November 24, 2021

Subject: Laurel Elementary School HVAC Replacement
San Mateo - Foster City School District
Aedis Project No. 2021005.03
DSA Application #01-119551

ADDENDUM NO. 1

SHEET # AD1-
A2.02

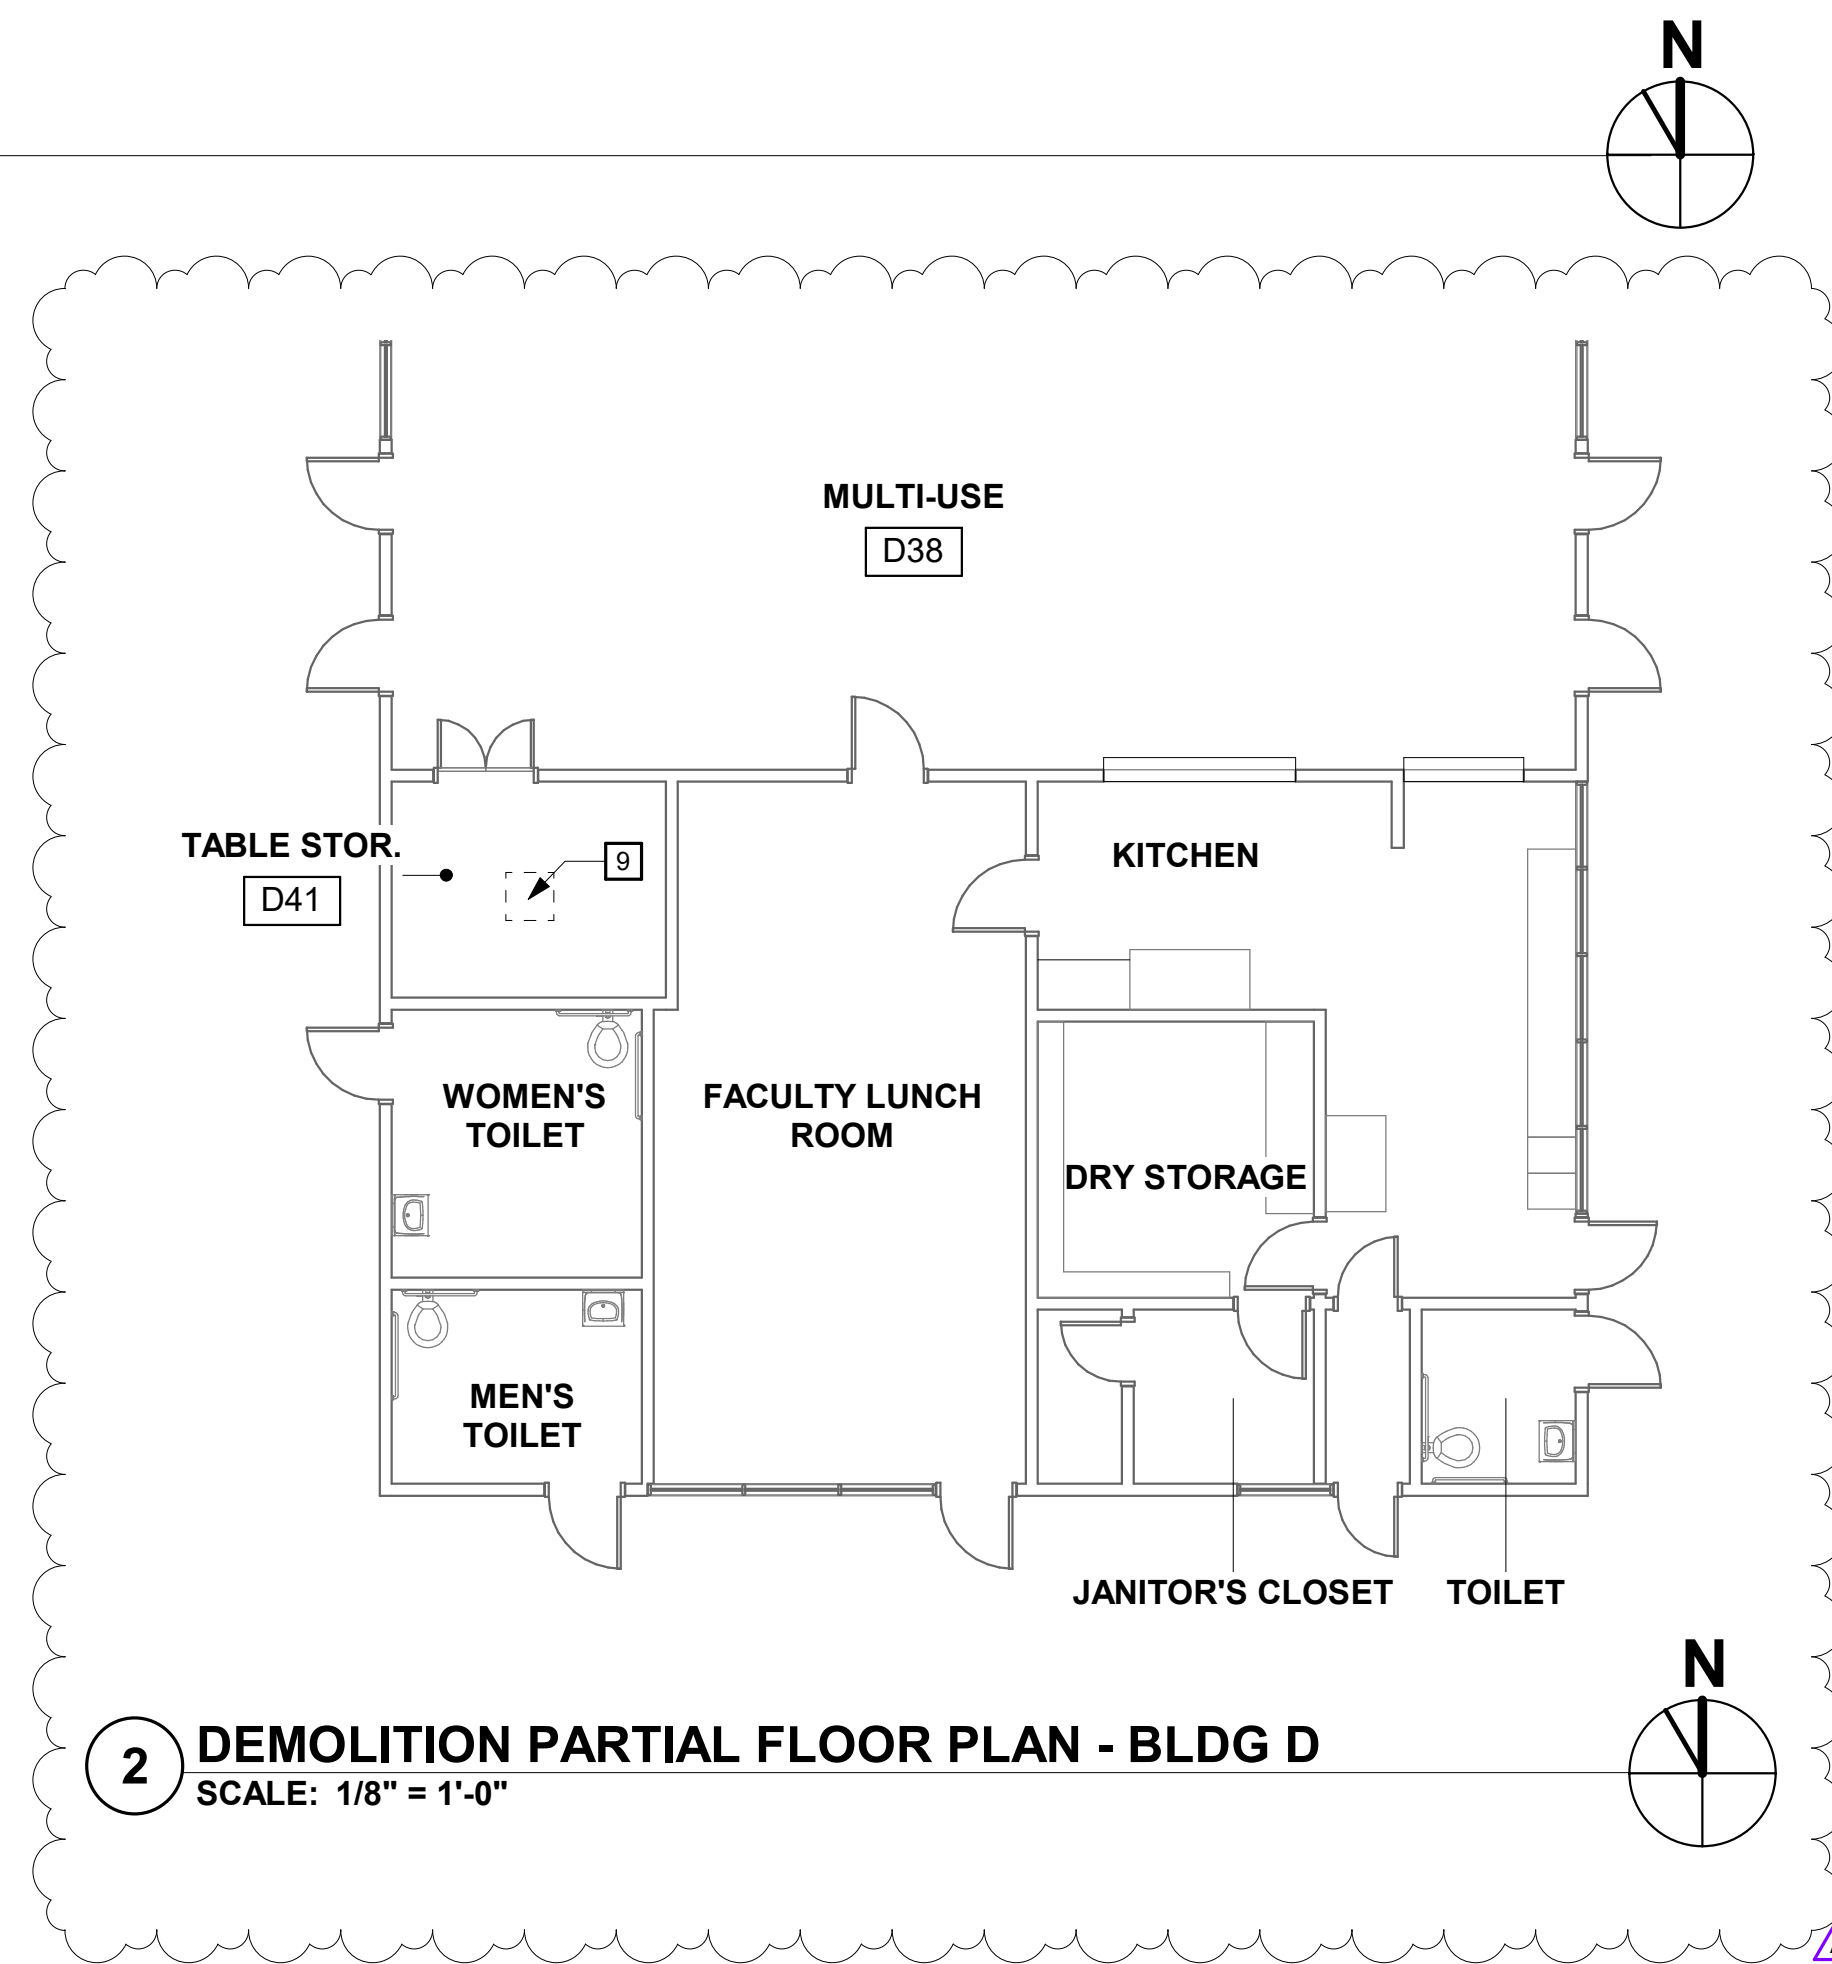
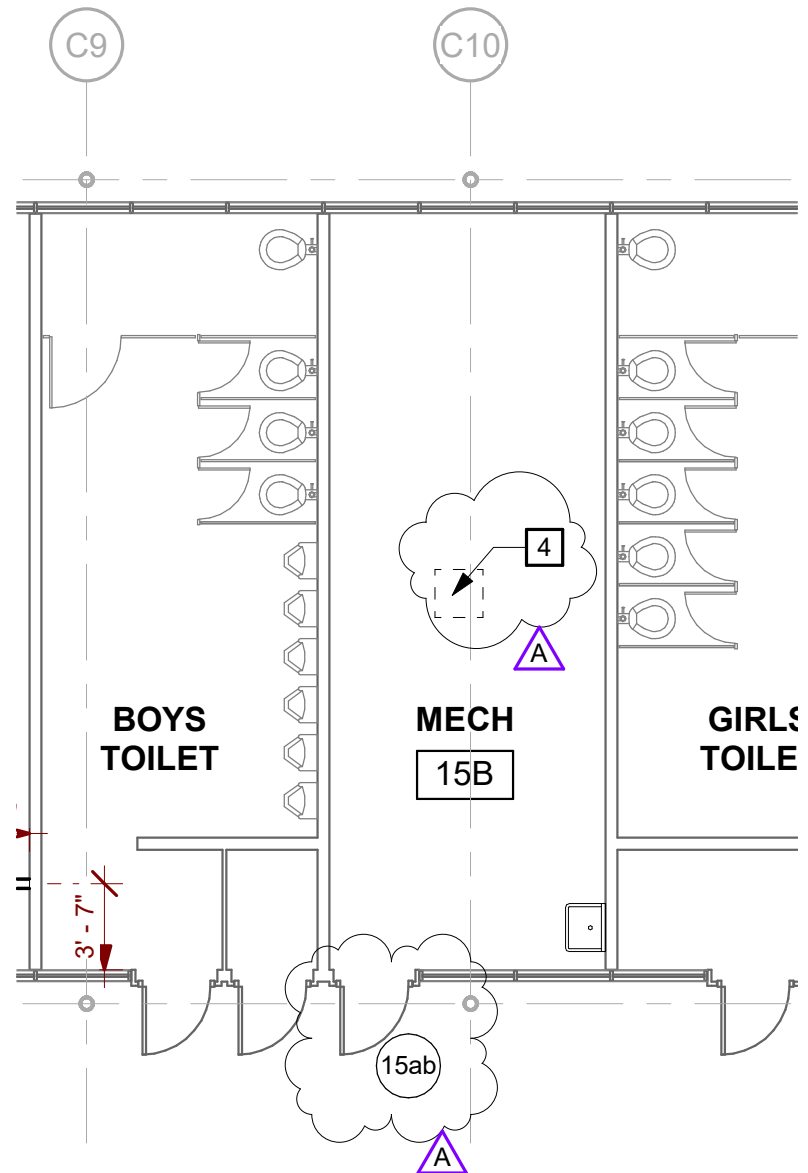
Add: General Sheet Note #J per AD1-A2.02

Revise: Demolition Floor Plan Keynote #1 per AD1-A2.02

Add: Filler panel removal keynote #8 to Demolition Floor Plans 1/A2.02 per AD1-A2.01

Add: Partial ceiling demolition keynote #9 to Demolition Floor Plans 1/A2.02 per AD1-A2.01

Add: View 2/A2.02 Demolition Partial Floor Plan – Bldg D per AD1-A2.02

1 NEW FLOOR PLAN - BLDG C
SCALE: 1/8" = 1'-0"

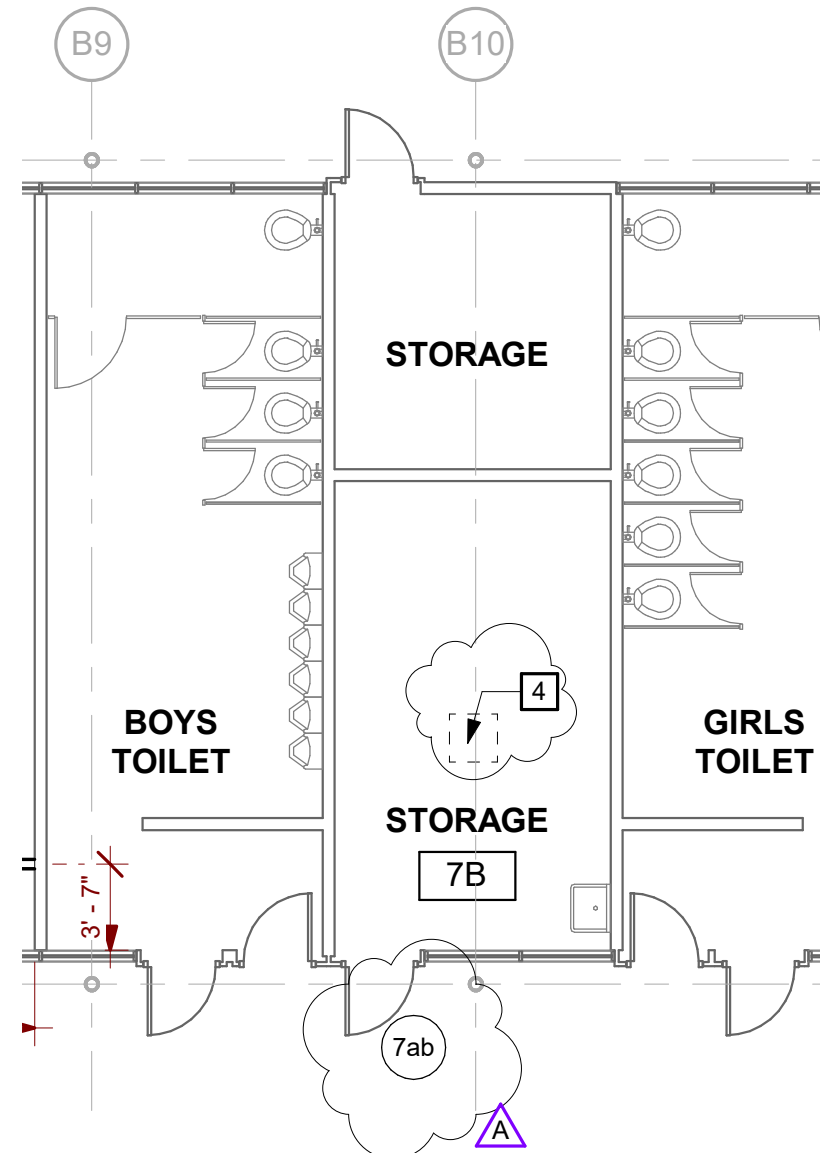
Add: Door tags 15ab & 7ab to 1/A3.01 and 2/A3.01 per AD1-A3.01

Add: Ceiling patching keynote #4 in New Floor Plans 1/A3.01 and 2/A3.01 per AD1-A3.01

Revise: New Floor Plan Keynote #3 per AD1-A3.01

NEW FLOOR PLAN KEYNOTES

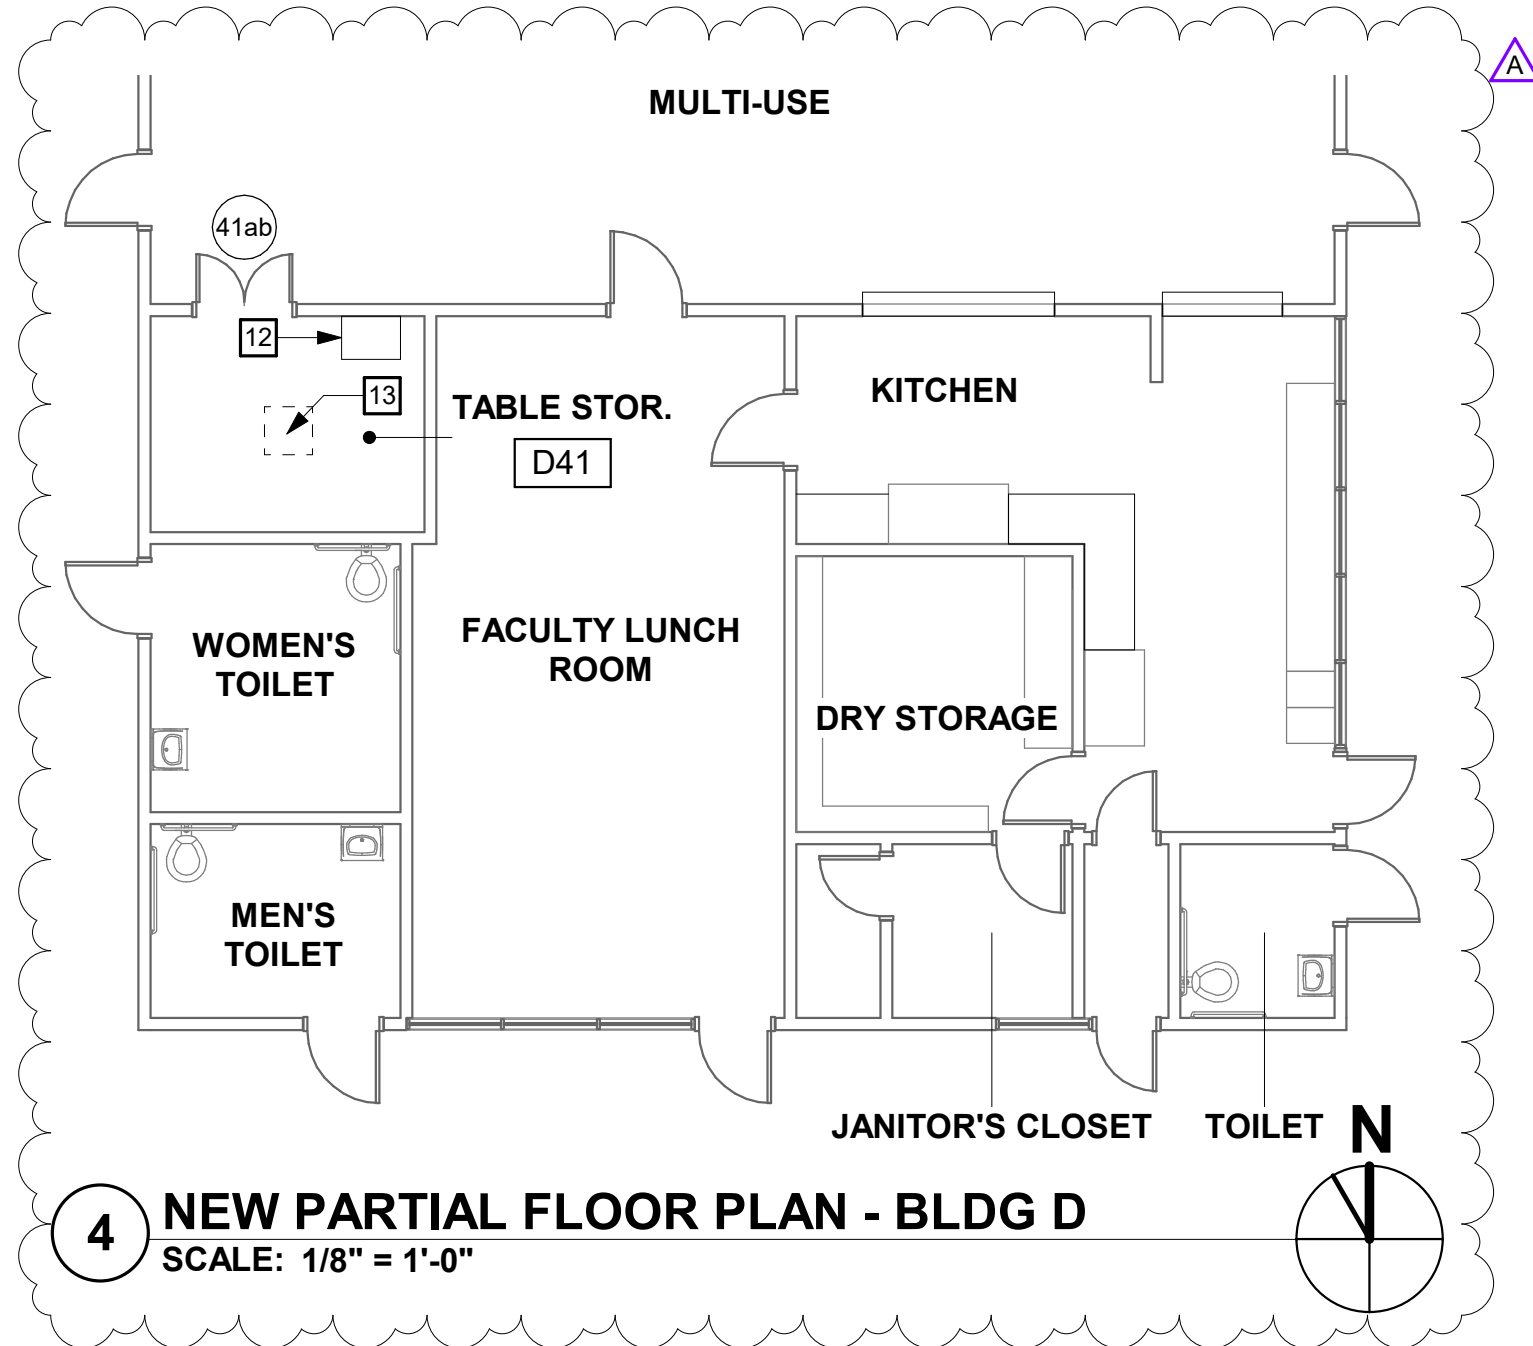
Add: View 4/A3.02 New Partial Floor Plan - Bldg. D per AD1-A3.02
Revise: New Floor Plan Keynote #6 per AD1-A3.02
Add: New Floor Plan Keynote #13 @ per AD1-A3.02
